**Eastonville Road – Londonderry Dr. to Rex Rd.
Segment 2 Improvements
Stationing 47+00.00 – 79+31.62**

Final Drainage Report

August 2024

CDR2321

SHEET DRN 1

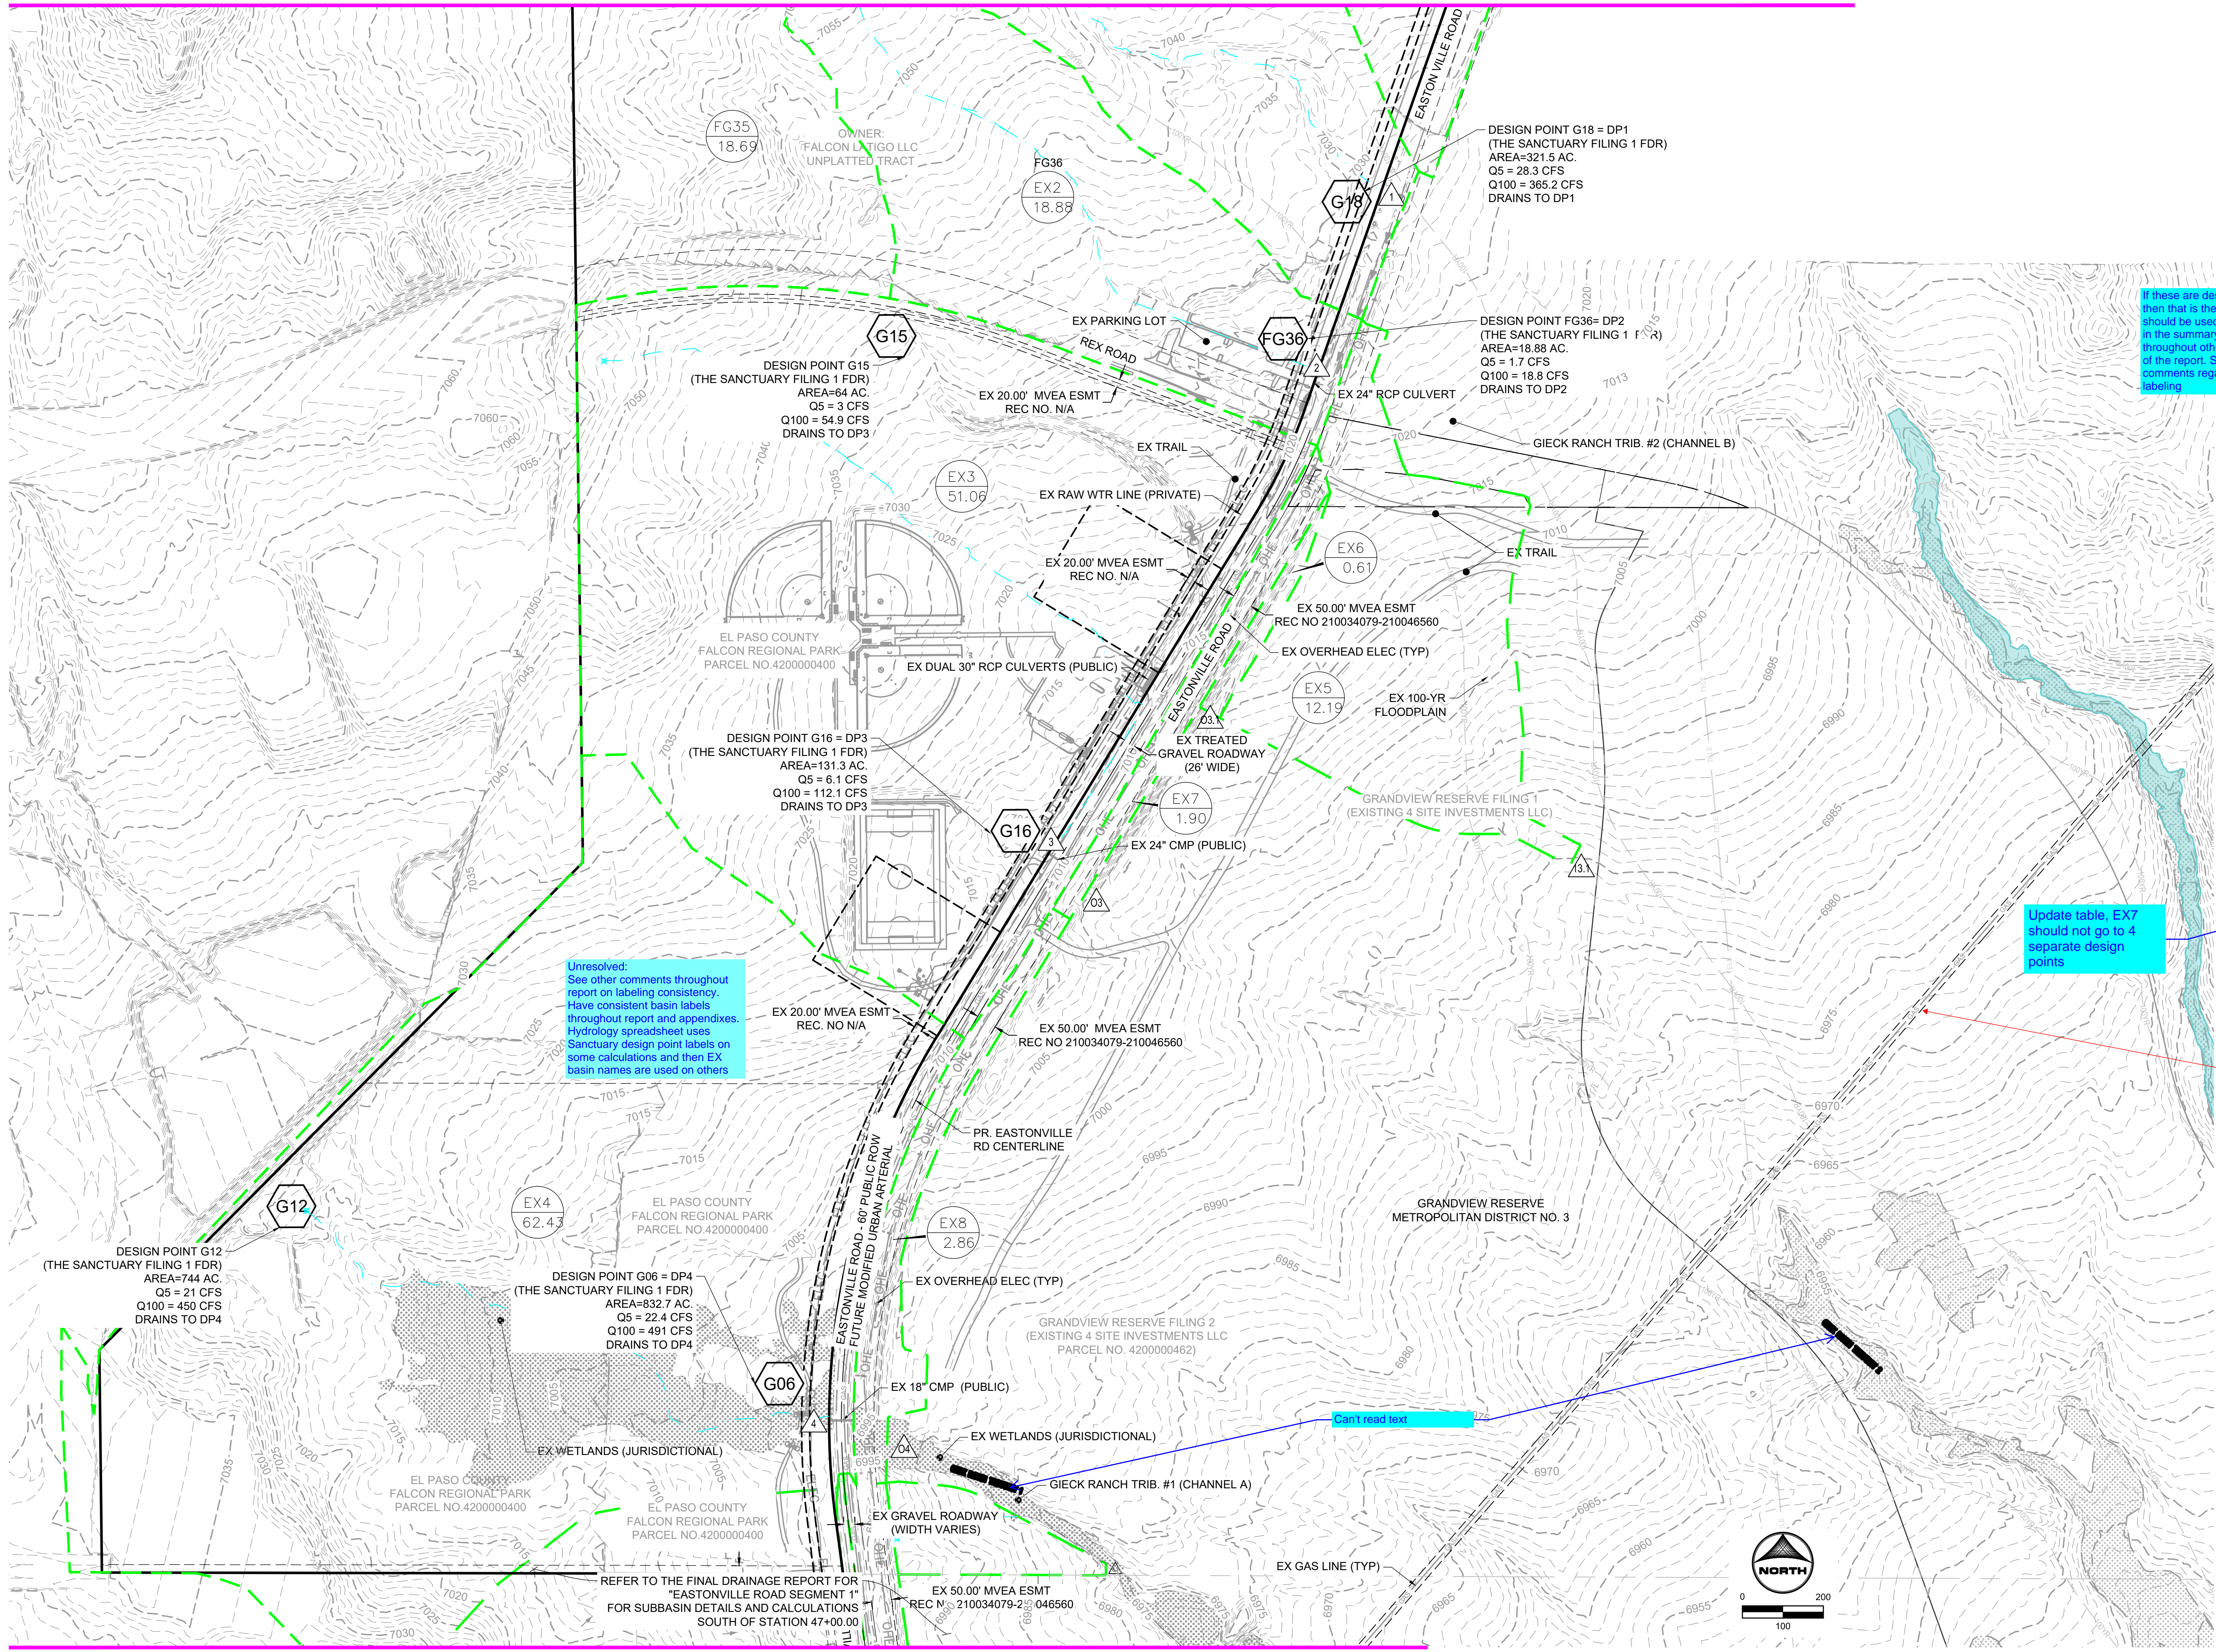
* AREA AND Q TAKEN FROM THE SANCTUARY FILING 1 FDR
 Unresolved:
 - Label all existing easements (all maps)
 - Could not find Design Points G15, G18, FG36, or G16 in the Sanctuary FDR for comparison. Recommended highlighting them in the reference section.

If these are design points, then that is the label which should be used under DP in the summary table and throughout other portions of the report. See other comments regarding labeling.

Unresolved:
 Labeling needs to be consistent throughout document. To keep it simple, would suggest using basin labels & design points used in Sanctuary Rpt. Highlighted items are listed as design points on map and & Sanctuary Rpt. Should be the same here. Use same basin labels as in Sanctuary Rpt and remove "new" basin labels within tables, maps, report, etc

Design calculations in appendix show box height of 3.0'. Please update so same information is shown throughout report.

Show riprap spillway

Show and label outlet protection

Unresolved:
Show and label Basin FG38

Unresolved:
Show and label existing culvert, mentioned in report. Show limits of water elevation overtopping roadway
